Memorandum

RE: 14034 Burntwoods Road
Glenelg, MD

Issue(s) to be Reviewed: Construction of rear enclosed porch without a permit

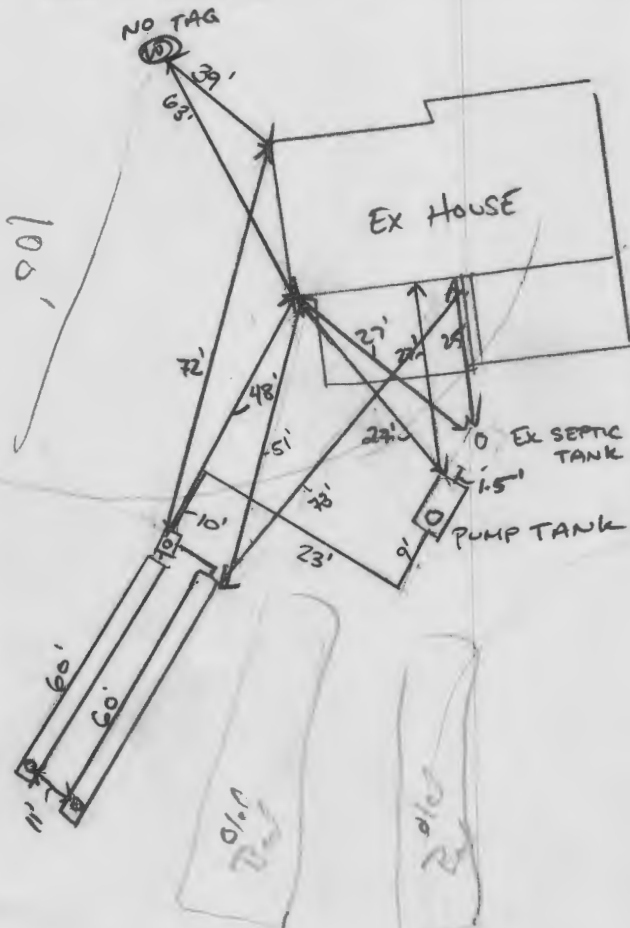
4/24/19 Found location of existing bed, will be more than 10' from it w/ new trenches. set new 1250 p.t. just after ex. ST. shut elevation for new 2x68' trenches as flagged in field, on four drops slightly more @ ends. (KMD)

INSTALLATION: 4/25/2019 RISER INSTALLED ON EX ST. OUTLET BAFFLE INSTALLED. PUMP TANK SET. FORCE MAINS INSTALLED TO D BOX. OK TO BACKFILL. @ 4/29/2019 TRENCHES COMPLETE. D Box FM TURN DOWN TO BAFFLE. OK TO BACKFILL. @ 5/3/19 P/A test OK. Did not make site visit (workload too busy). Contractor confirmed both working (KMD) 5/6/19 Did make it to site w/ contractor to perform P/A test. 'OK' (KMD)

37012
A REPAIR

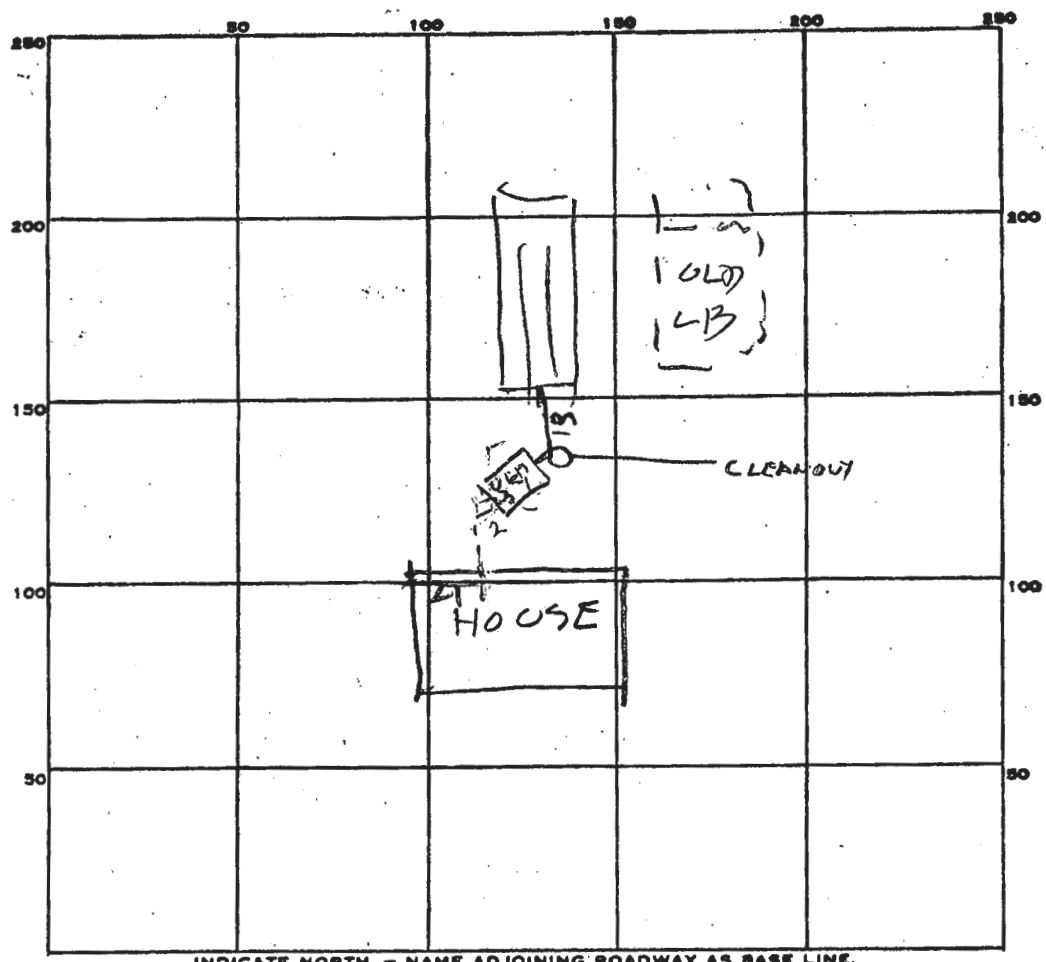
REMARKS 5/13/86 ^{160N} OLD LB INSTALLED 1969
MOST OF BED DUG. VISUAL HOLE DUG
FINISH DIGGING BED & ADD STONE
5/13/86 ^{1130 AM} BED DUG LONGER STONE
ADDED RH

37017
A REPAIR

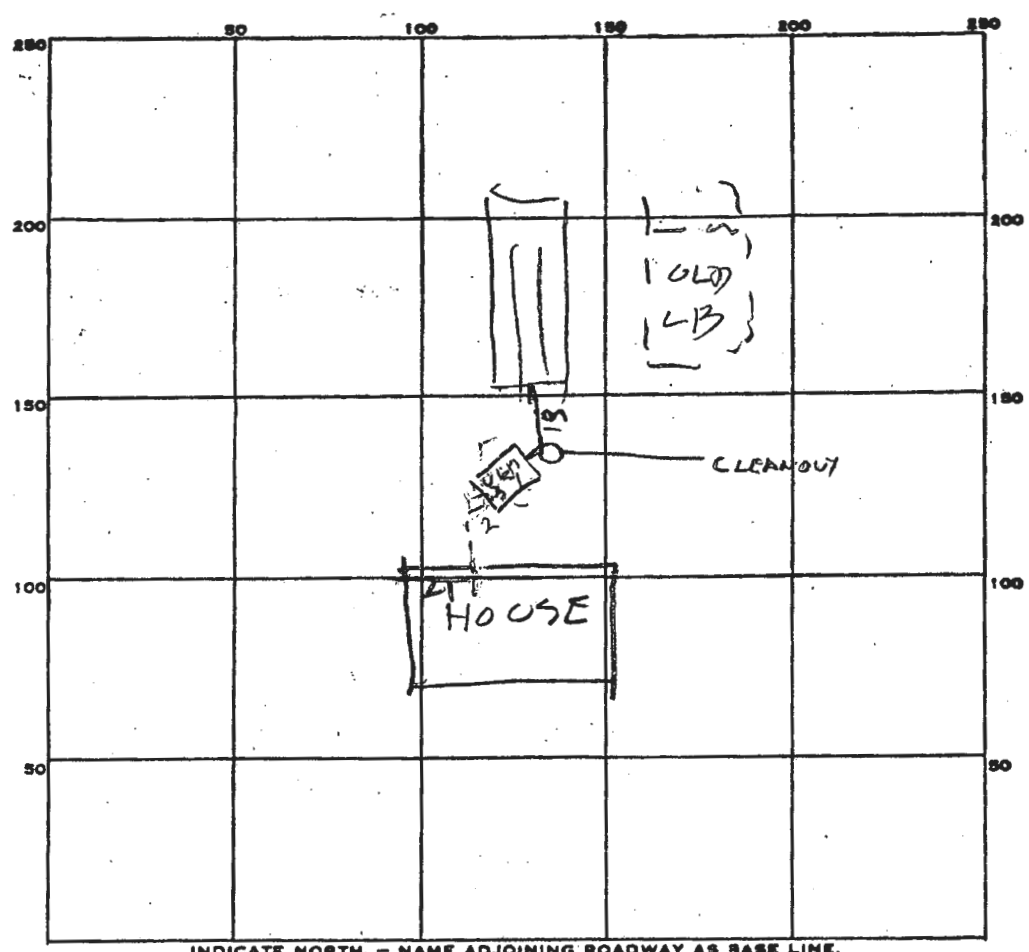
REMARKS 5/13/86^{100N} OLD LB INSTALLED 1969
MOST OF BED DUG. VISUAL HOLE DUG
FINISH DIGGING BED & ADD STONE
5/13/86^{1130 AM} BED = DUG LONGER STONE
ADDED RH

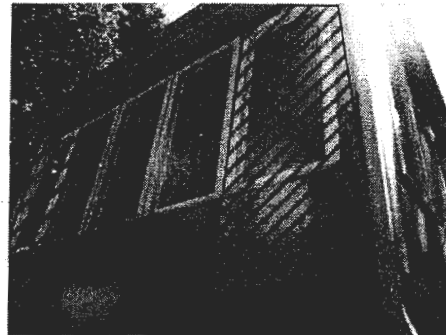
- The rear wall of the sunroom has very little solid wall area compared to the area of window openings. We feel that there are two options for addressing/remedying the wind-bracing requirements:

1. It *might* be possible to retain the current configuration of the windows and still meet wind-bracing requirements. We feel that a pair of pre-engineered elements can be 'inserted' in the wall at each end. A Simpson SSW12x8 Steel Strong Wall can be installed at each corner of the rear wall. This would necessitate: removing the trim, removing the exterior finish, temporarily supporting the sunroom structure, removing the plywood, cutting out the wall studs, and 'sliding' the steel wall panels into the wall cavity. This would also necessitate constructing a pair of 16"x16" CMU piers at the outside corners of the sunroom (these Steel Strong Wall panels must be fastened to a foundation element), which would also necessitate new footings. We recommend discussing this option with a contractor for better information on feasibility and pricing.

2. The simplest solution, in our opinion, would be to abandon the left and right windows on the rear wall. In short, the exterior trim and finishes would need to be removed, the windows at the corners would need to be removed, and the existing plywood wall sheathing would need to be removed. New infill wall studs would need to be provided to close the window openings, and new 1/2" plywood sheathing (with fasteners at 6" on center at plywood edges and 12" on center at all intermediate studs) be provided. This would satisfy the code wind-bracing requirements at this wall, in our opinion.
